CNRO-2003-00063

SUBJECT: Entergy Operations, Inc.  
Requests for Relief from ASME Section XI Volumetric Examination  
Requirements

Arkansas Nuclear One, Unit 1  
Docket No. 50-313  
License No. DPR-51

- Enclosures:
1. Relief Request ANO1-ISI-001
  2. Relief Request ANO1-ISI-002
  3. Relief Request ANO1-ISI-003
  4. Relief Request ANO1-ISI-004

Component ID: 03-047

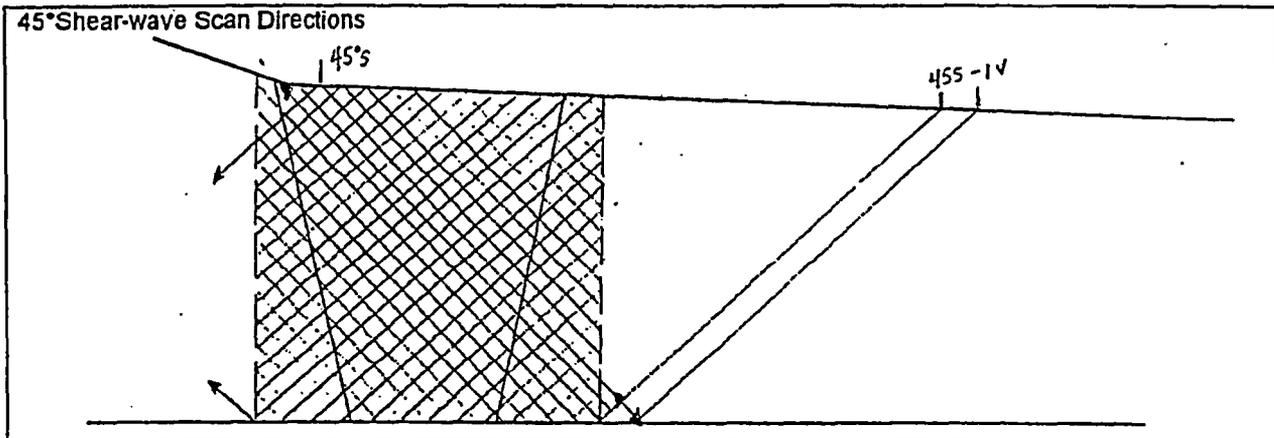
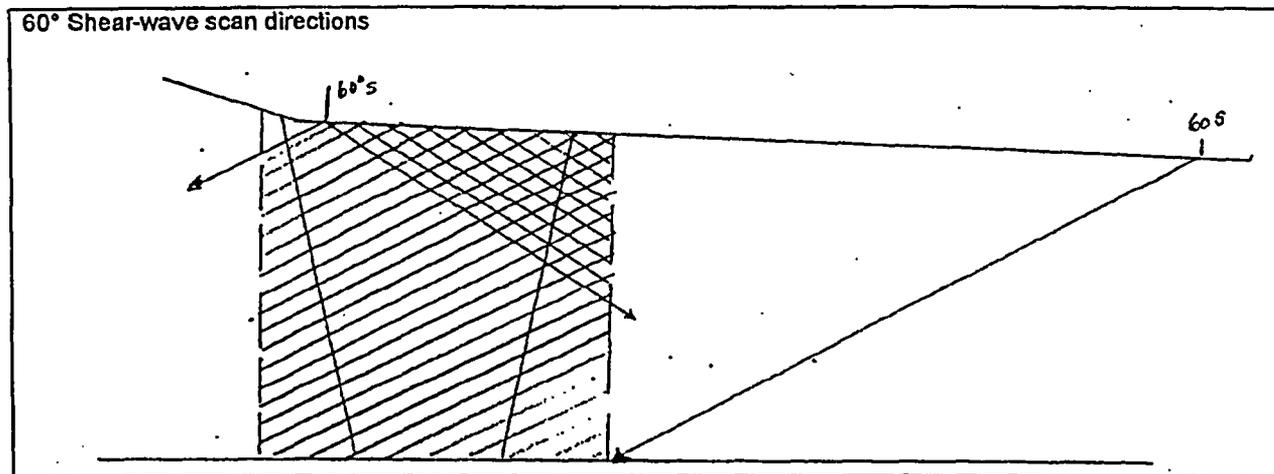
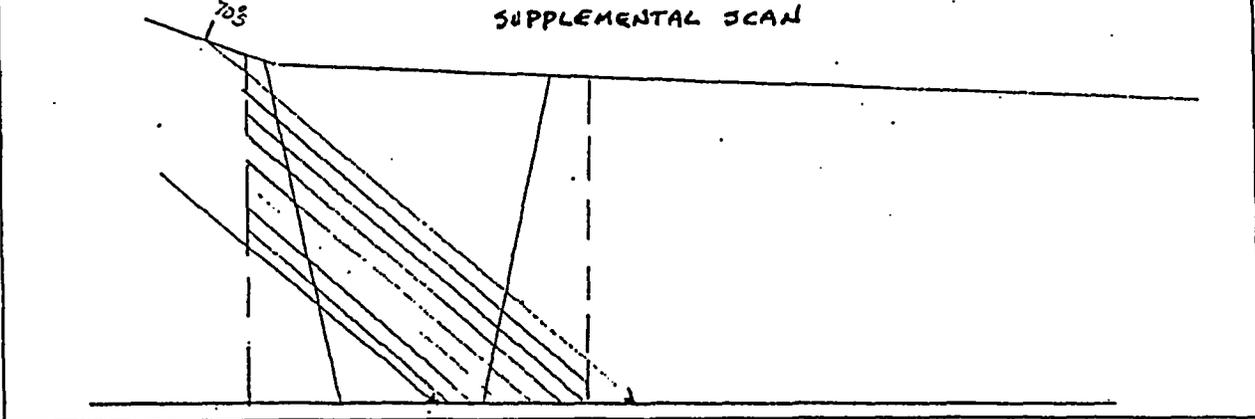
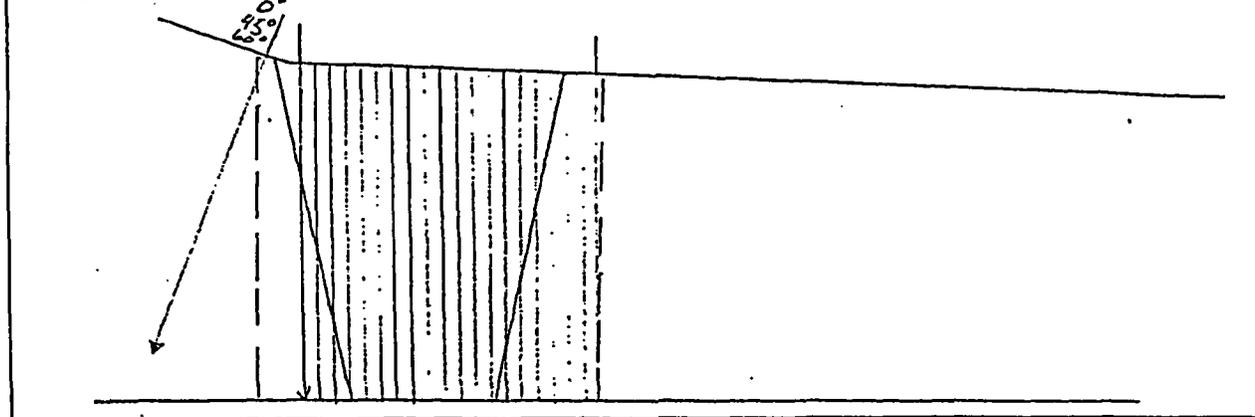
**COMMENTS:** Steam generator upper nozzle belt to upper shell weld. The primary limitation was on the required circumferential scans on the upper nozzle belt taper, base material. The cumulative coverage estimation includes the code required base metal coverage adjacent to the weld and the factor of multiple angles from multiple directions.

Component ID: 03-001

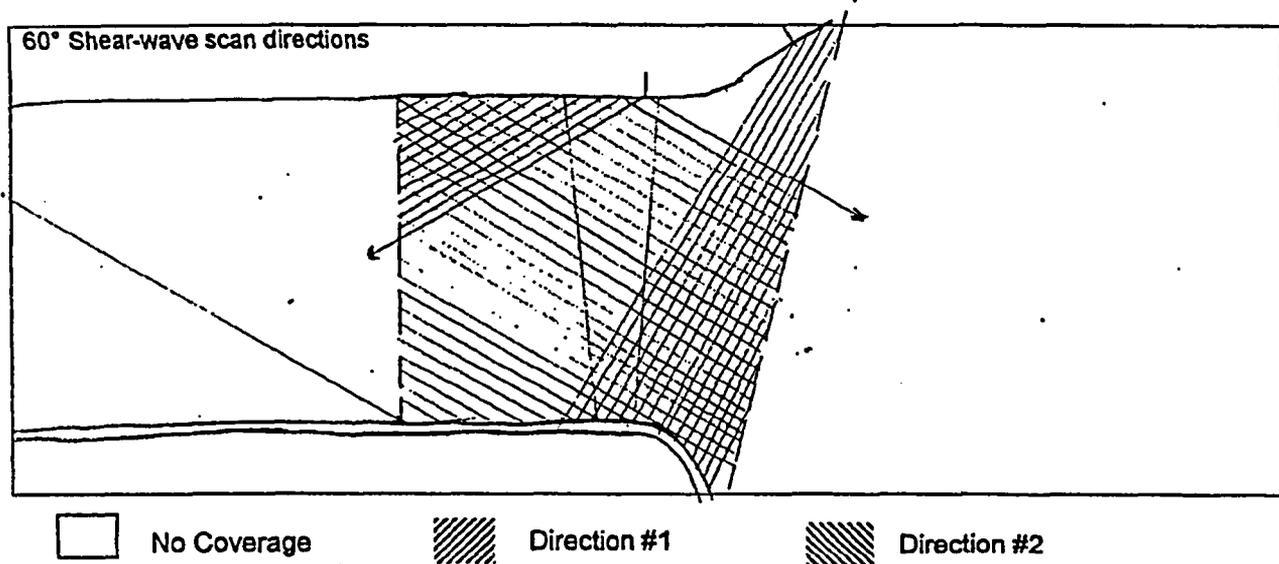
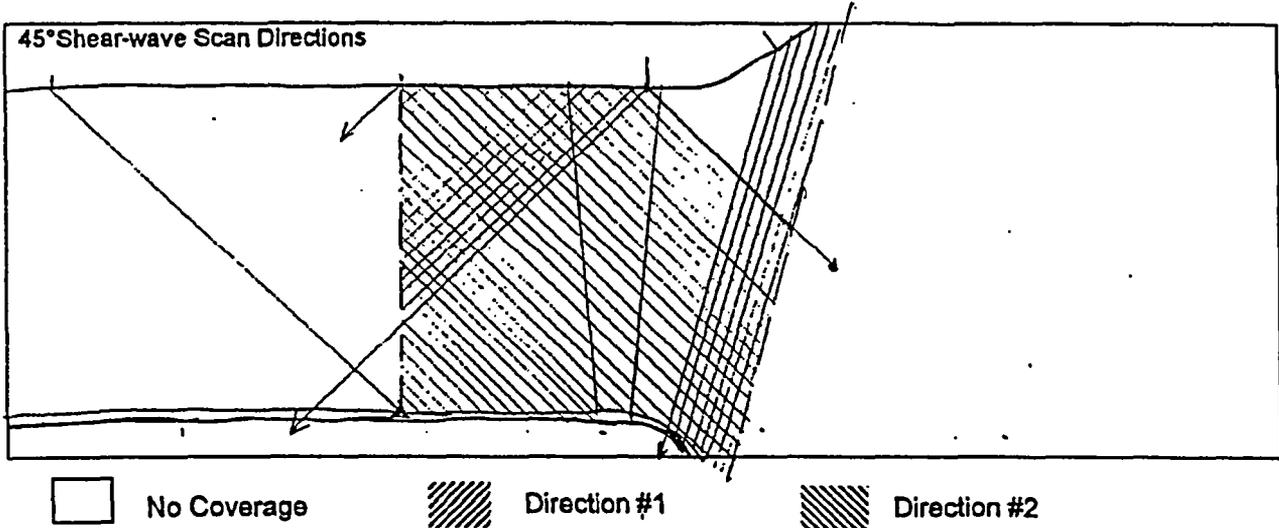
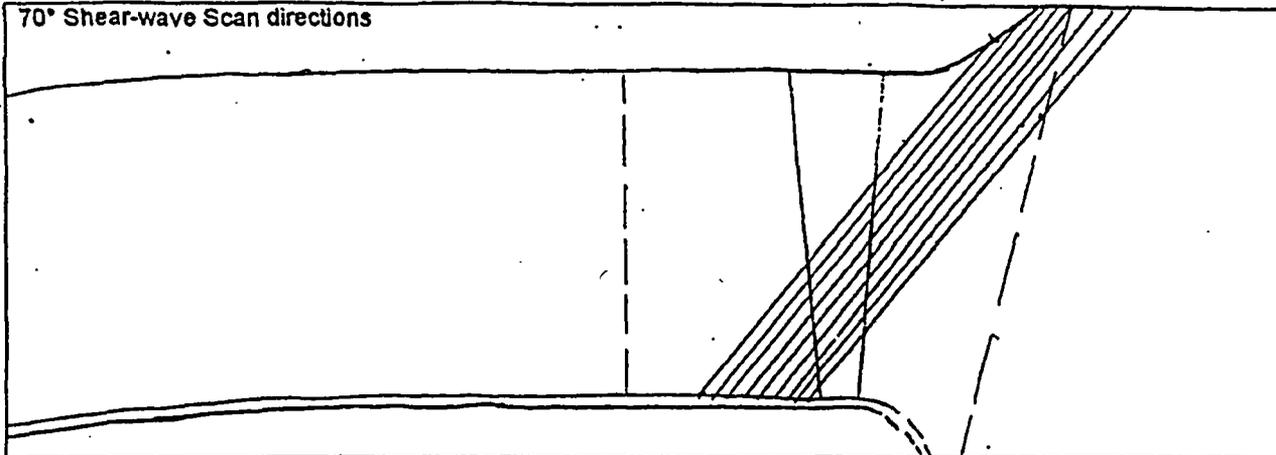
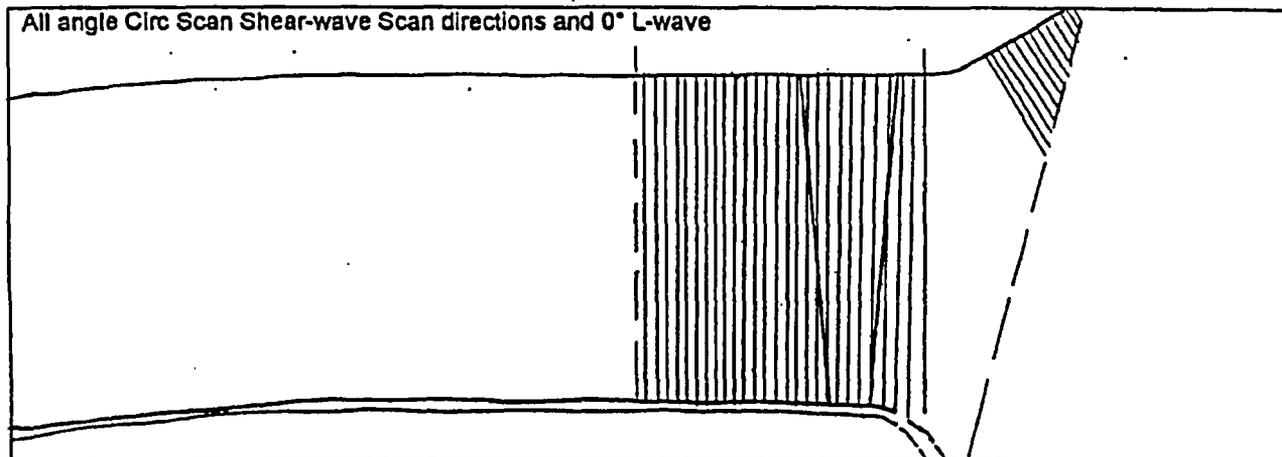
**COMMENTS:** Upper head to tube-sheet weld approximately 426 inches in circumference. Primarily a single side examination from the upper head, however, some coverage was obtained scanning from the taper on the tube-sheet side. The cumulative coverage estimation includes the code required base metal coverage adjacent to the weld and the factor of multiple angles from multiple directions. The scan from the head was limited for approximately 47 inches due to integral attachments and the manways.
